ADDENDUM No. 1

PROJECT: City of St. Charles – S. 7th Avenue & Division Street Lift Station

PROJECT NUMBER: STC-112

Project No.: STC-112
 Base File:
 Sheet File: C.1.DGN
 Issue Date: 10/12/2018
 Scale: 1" = 10'
 Sheet Number
C.1

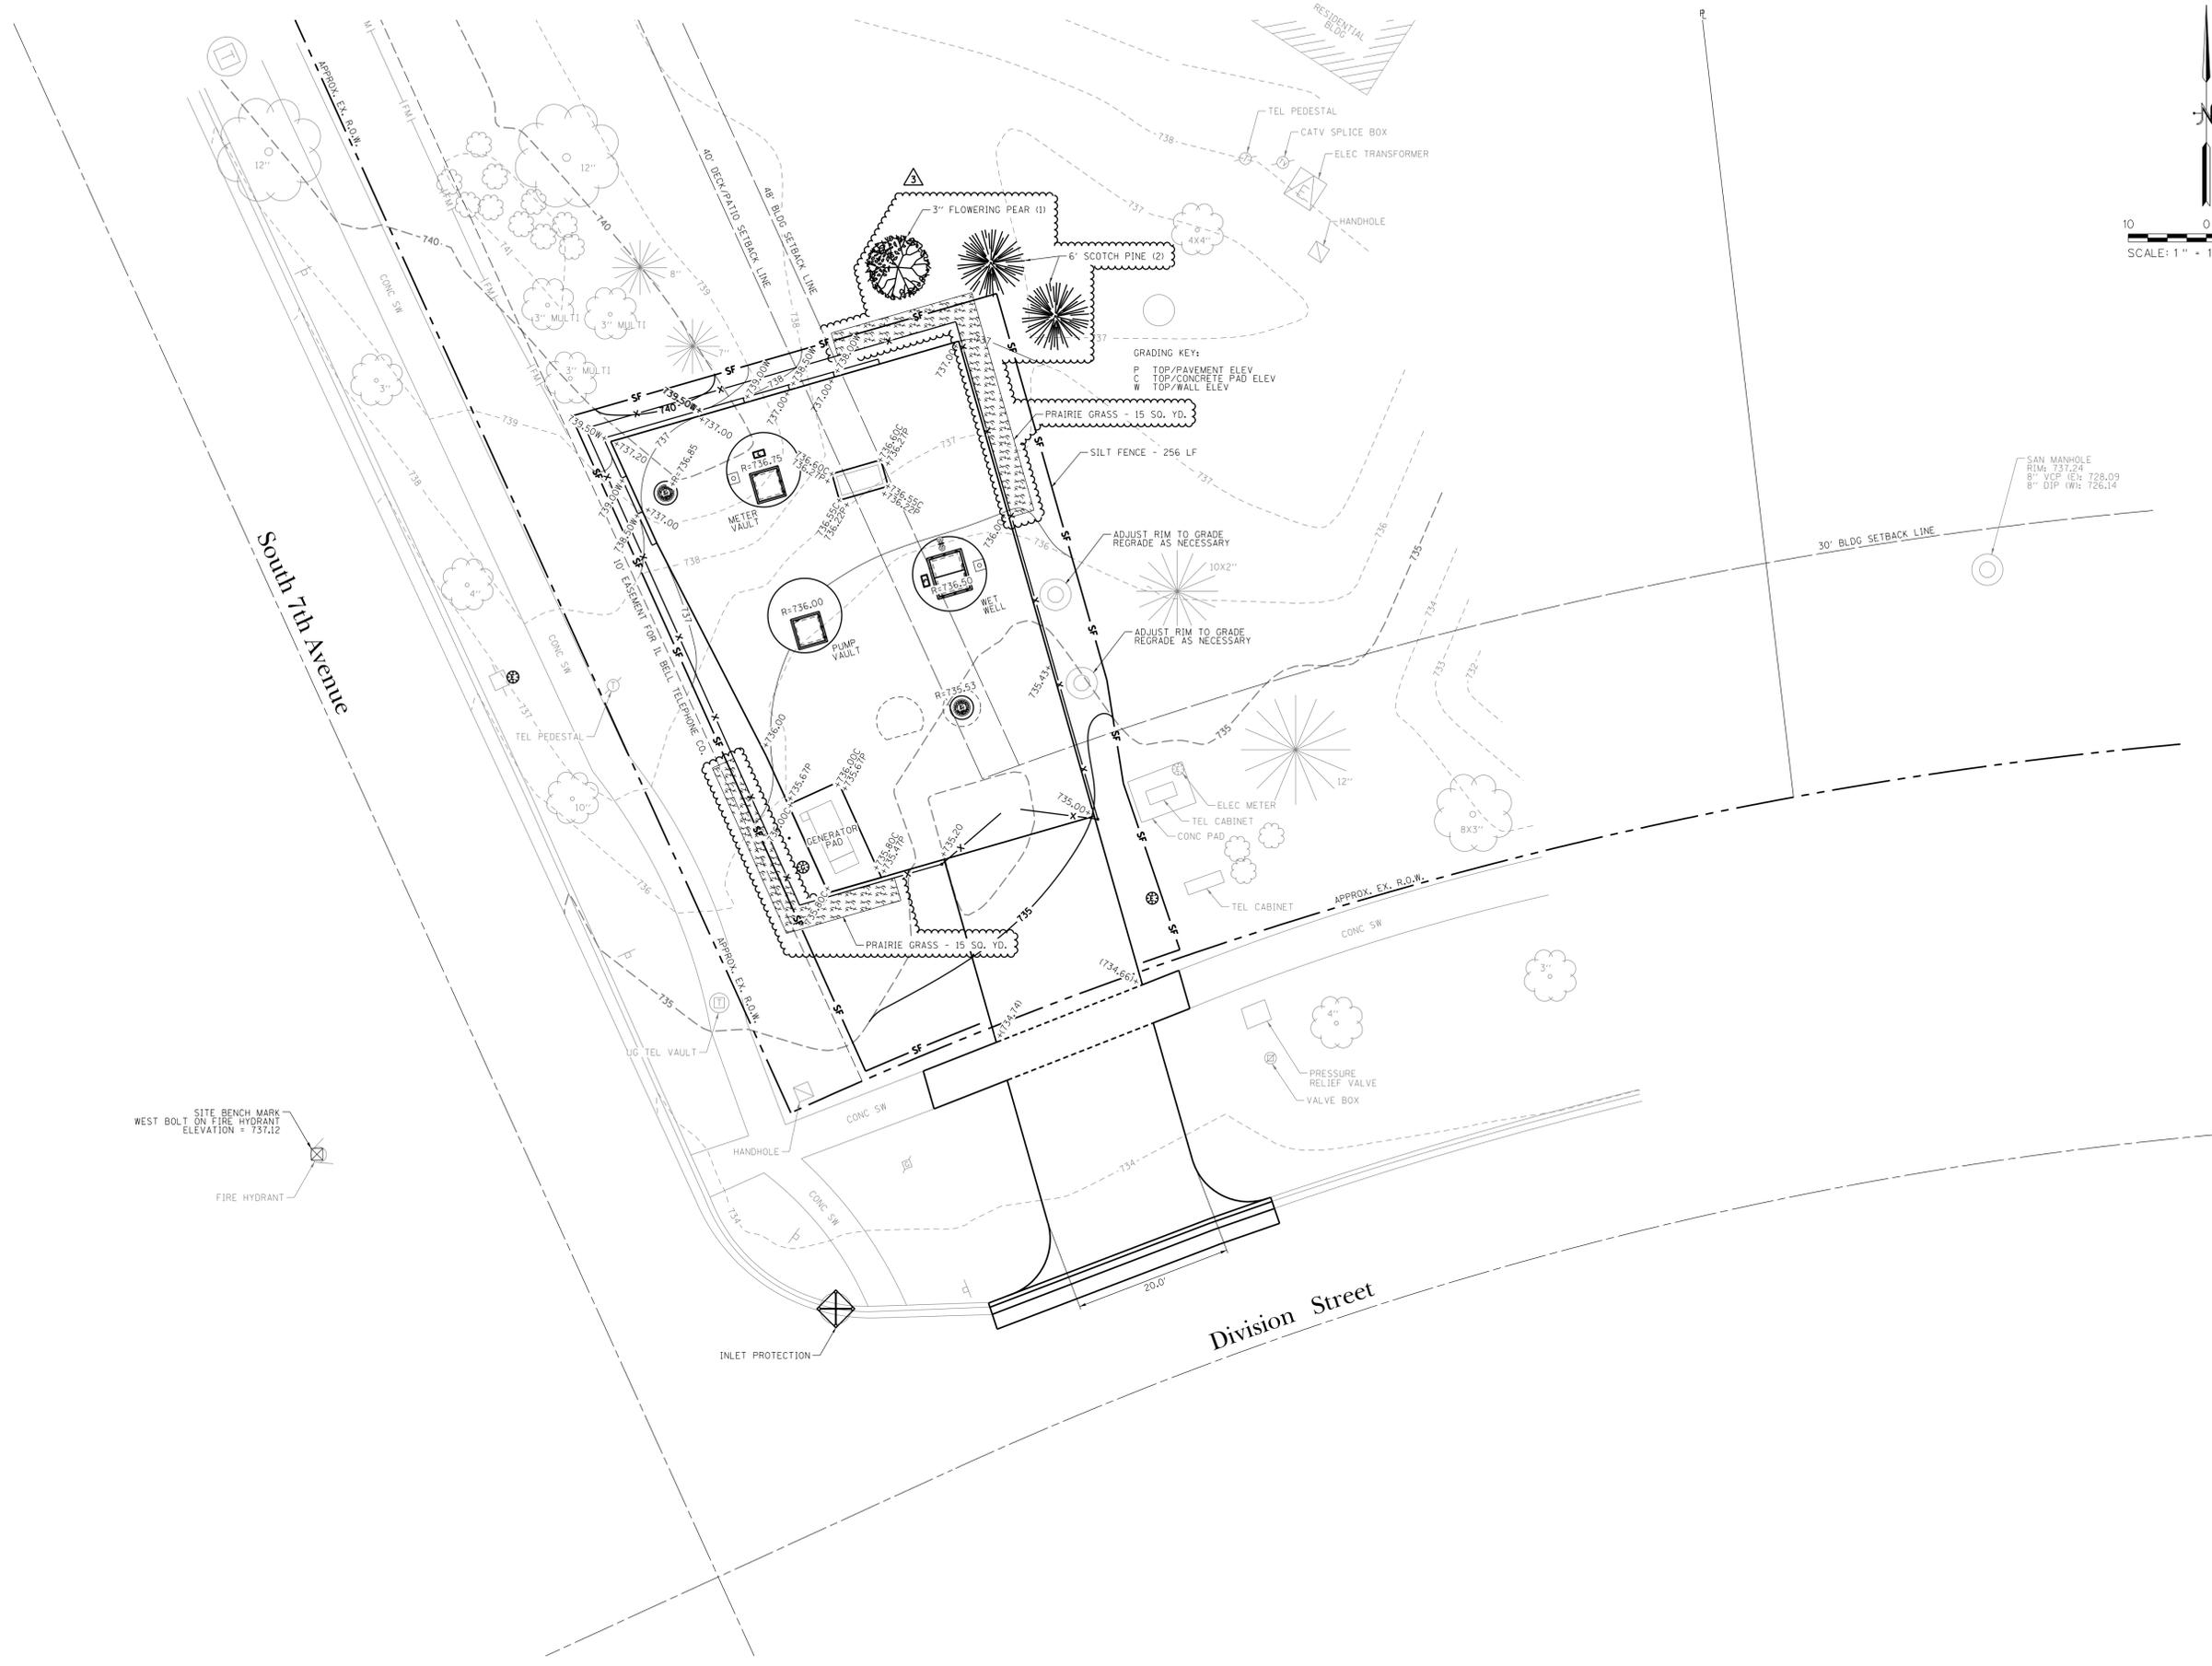
2. Drawing C.1

- A. Added landscaping.

One-Line Diagram
NO SCALE

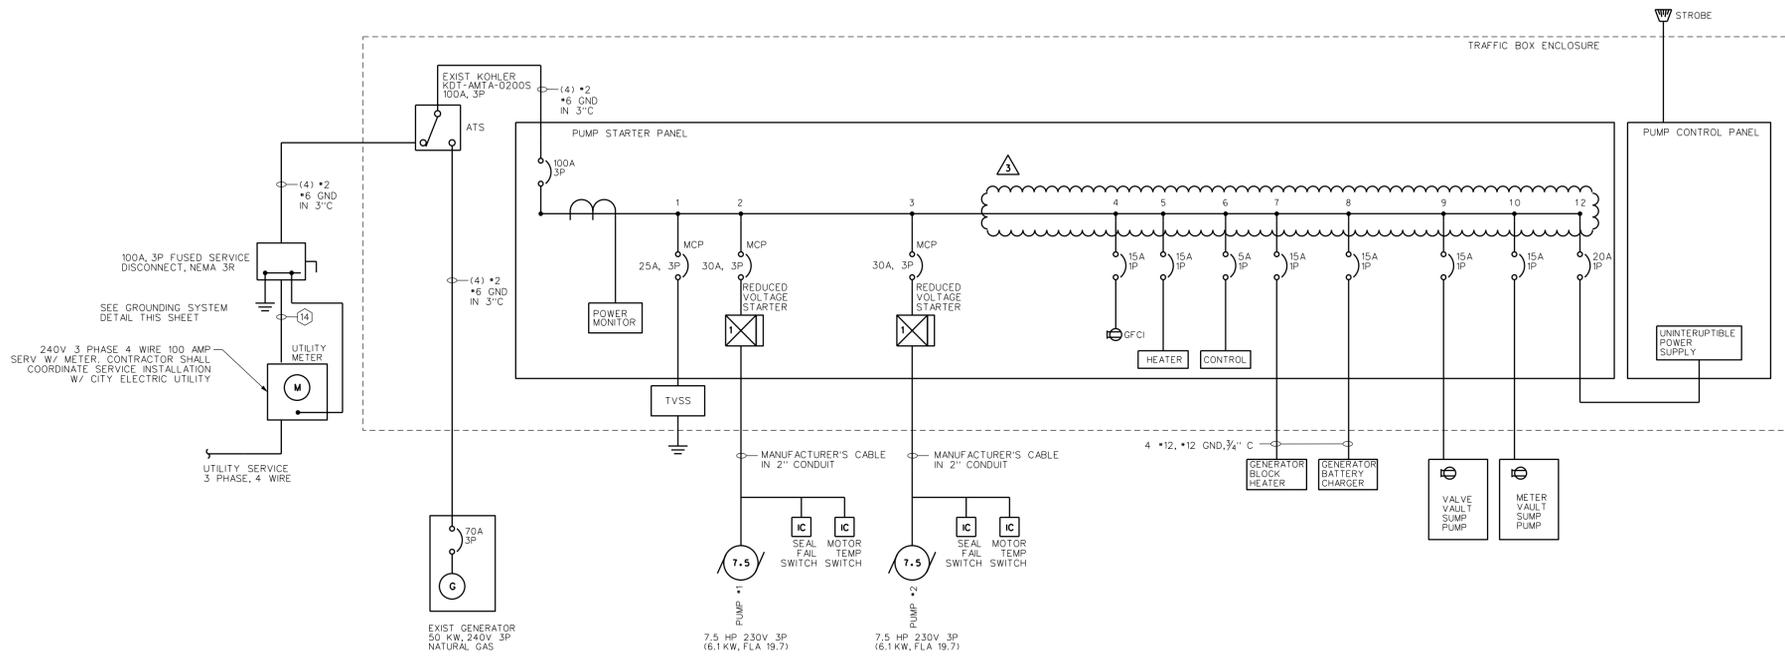
5. Drawing E.2

A. Removed Node 4 from one-line diagram, renumber nodes.
